NPP FENNOVOIMA (HANHIKIVI 1)

Expert Statement to the EIA Program

Oda Becker

Figure 1: VVER Technology Evolution

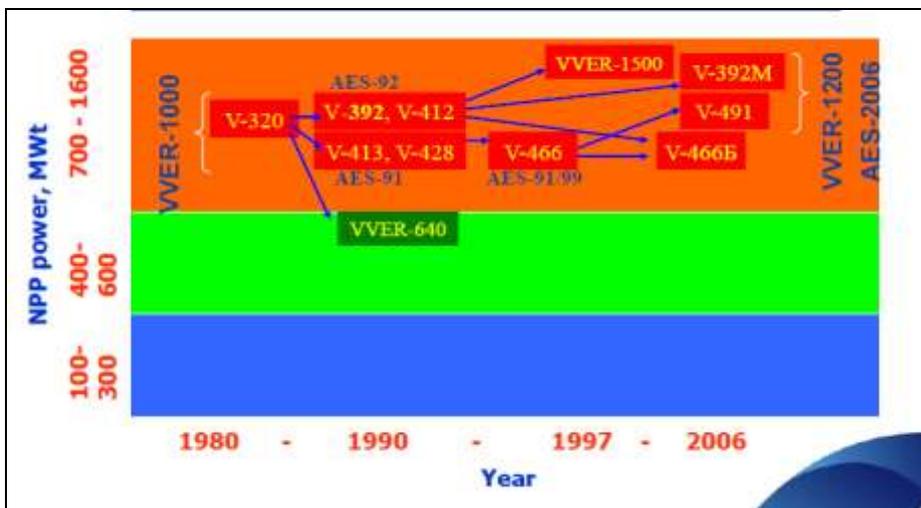
Two variants of the AES-2006 have been developed (see figure 1): Passive safety systems prevail in the type VVER-1200/V-392M, whereas the type VVER-1200/V-491 focuses more on active systems (UMWELTBUNDESAMT 2009b). The EIA program does not mention which variant is chosen for Hanhikivi 1. **It is recommended to explain which variant of the AES-2006 is chosen as well as the reason for this choice.**
